Addendum 85 – UN Regulation No. 86

Revision 3 - Amendment 4

Uniform provisions concerning the approval of agricultural or forestry vehicles with regard to the installation of lighting and light-signalling devices

Figure 1

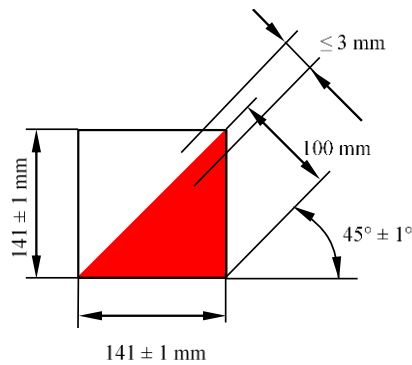
Paragraph 1.1, amend to read:

"1.1. Signalling panels and signalling foils shall have the following dimensions:"

Figure 2

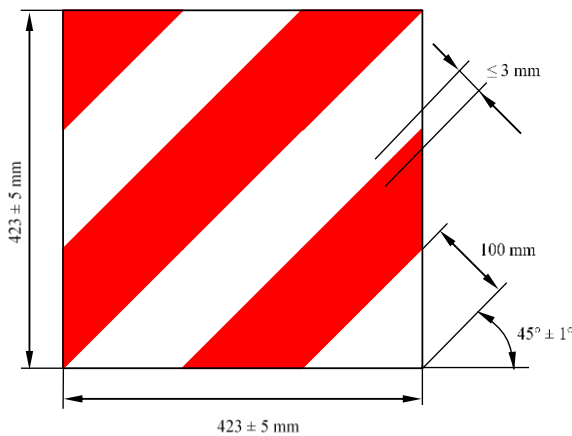
Paragraph 1.1, Table 1, amend to read:

Deviations from the specified formats are permitted, provided that:

- (a) The visible surface of each panel or foil shall be at least equal to 4 basic standard areas and
- (b) Each panel or foil shall comprise at least 3 entire basic standard areas.

If the structure, design or the operational use of the vehicle makes it impossible to comply with such a requirement, each panel or foil may be split into 2 parts as long as each part comprises at least 2 entire basic standard areas."
